**SUBDIVISION,
PLANNED UNIT DEVELOPMENT, &
REZONING STAFF REPORT**

Date: March 17, 2016

R J Estates Subdivision

SITE PLAN

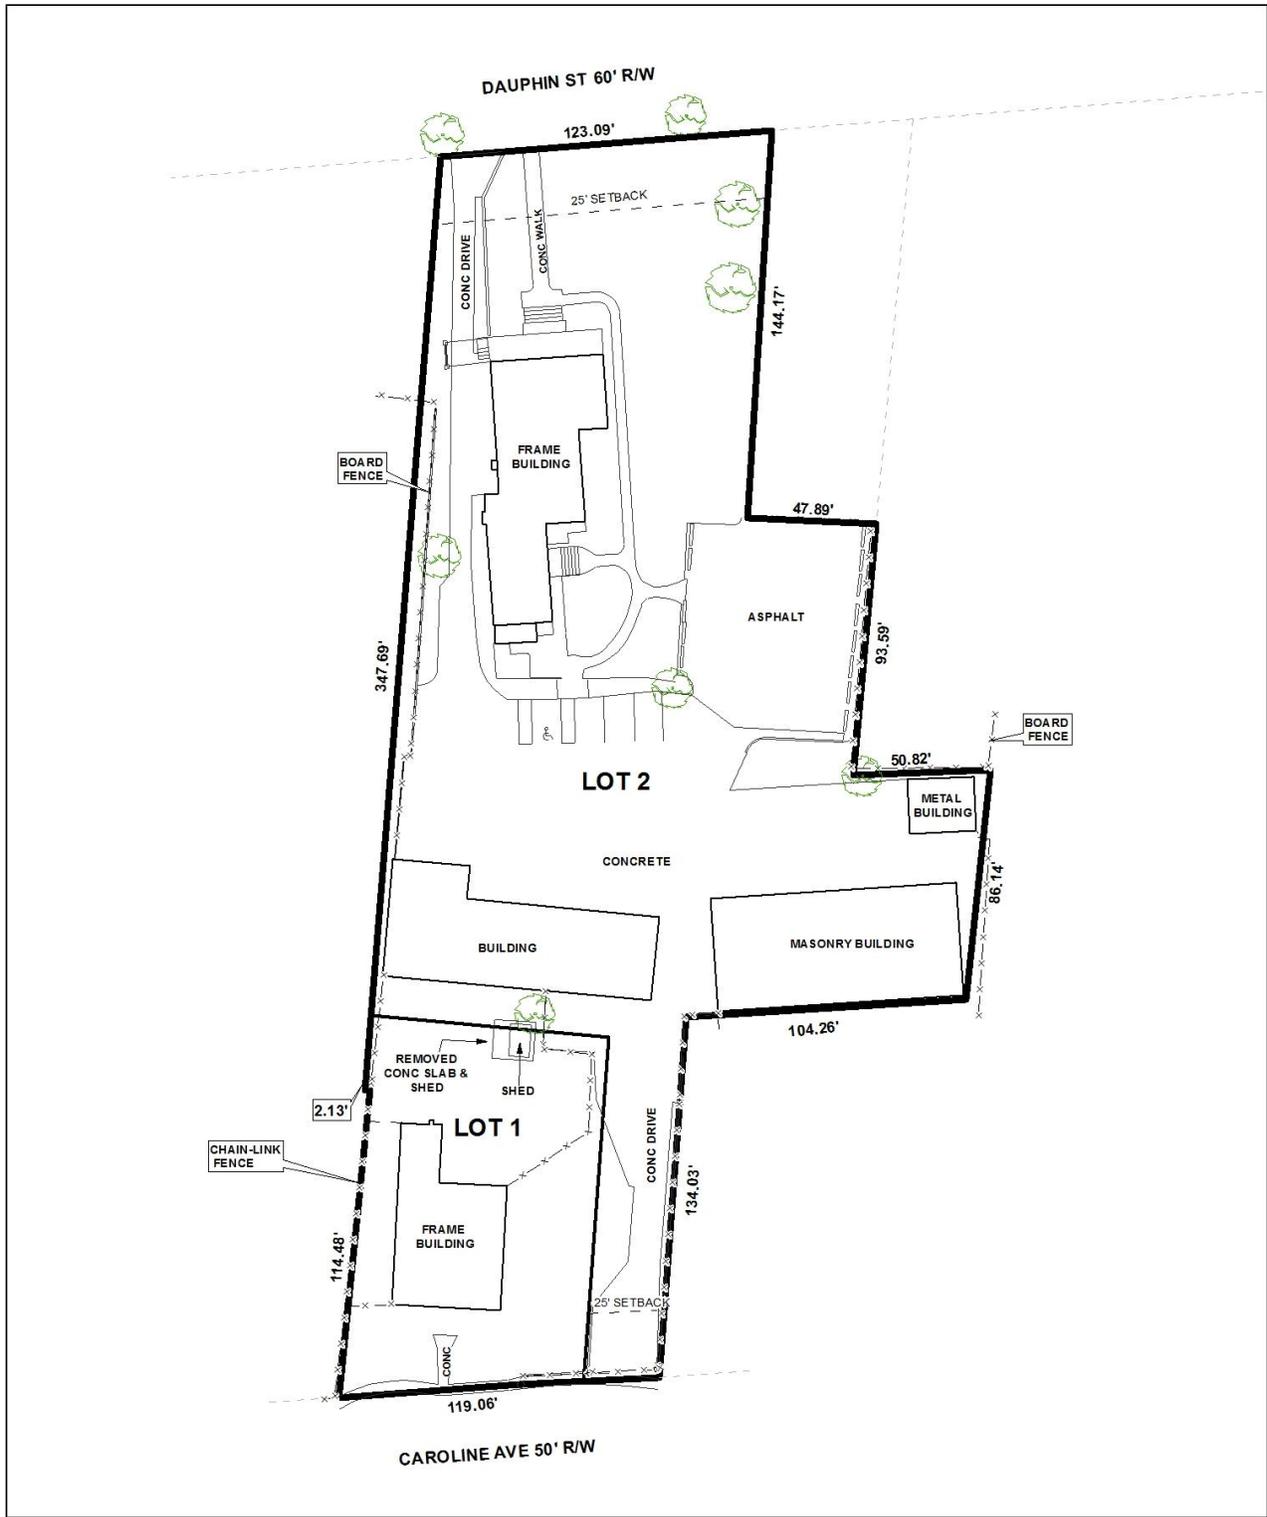
With regard to the PUD, the site plan depicts one designated accessible parking space, and all other parking is un-designated. The size of the two-story office building is not provided, thus staff cannot determine how many parking spaces might be required. There also may be insufficient buffering along adjacent residential sites and no dumpster is indicated. No sidewalk is shown (which actually exists) along Dauphin Street. The site plan should be revised to provide information regarding the size of the office use in square feet, as well as parking calculations and indication of compliant designated parking.

The site plan should be revised to either indicate a compliant dumpster or a note should be placed on the site plan stating that no dumpster will be utilized and refuse collection will be via curbside or private can collection services. The site plan should also be revised to indicate the existing public sidewalk along Dauphin Street.

- 7) revision of the site plan to provide the office size in square feet and to provide parking calculations and indicate compliant designated parking (including any require accessible parking);

- 8) revision of the site plan to indicate compliant residential buffering where the site adjoins existing and proposed residential use, except along the West side of the drive from Caroline Avenue;

- 9) revision of the site plan to provide a compliant dumpster, or the placement of a note on the site plan stating that no dumpster will be utilized and refuse collection will be via curbside or private can collections services;

- 10) revision of the site plan to indicate the existing public sidewalk along Dauphin Street;
- 11) subject to the Engineering comments: *[ADD THE FOLLOWING NOTES TO THE PUD SITE PLAN: 1. Any work performed in the existing ROW (right-of-way) such as driveways, sidewalks, utility connections, grading, drainage, irrigation, or landscaping will require a ROW permit from the City of Mobile Engineering Department (208-6070) and must comply with the City of Mobile Right-of-Way Construction and Administration Ordinance (Mobile City Code, Chapter 57, Article VIII). 2. A Land Disturbance Permit application shall be submitted for any proposed land disturbing activity with the property. A complete set of construction plans including, but not limited to, drainage,*
